Company	Trenz Electronic GmbH
PCN Number	PCN-20220309
Title	TE0715-04 to TE0715-05 Hardware Revision Change
Subject	Hardware Revision Change
Issue Date	2022-03-14

This change affects all Trenz Electronic TE0715 SoMs of revision 04.

Affected Product	Replacement
TE0715-04-*	TE0715-05-*

2.26 #26 Change schematic documentation.

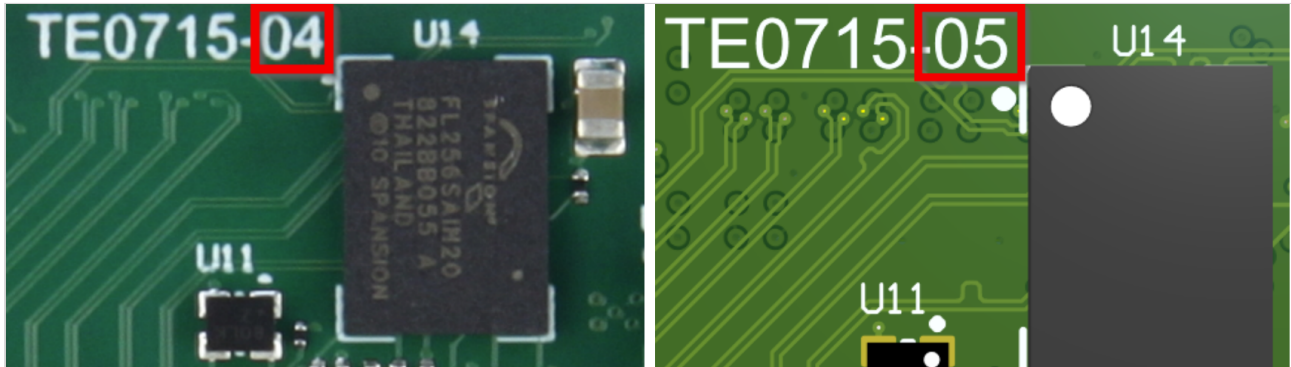
Type: DOC Change

Reason: Documentation optimization.

Impact: None. B2B information, legal notices, revision history, system overview, and power diagram are inserted or changed. Schematic page number changes.
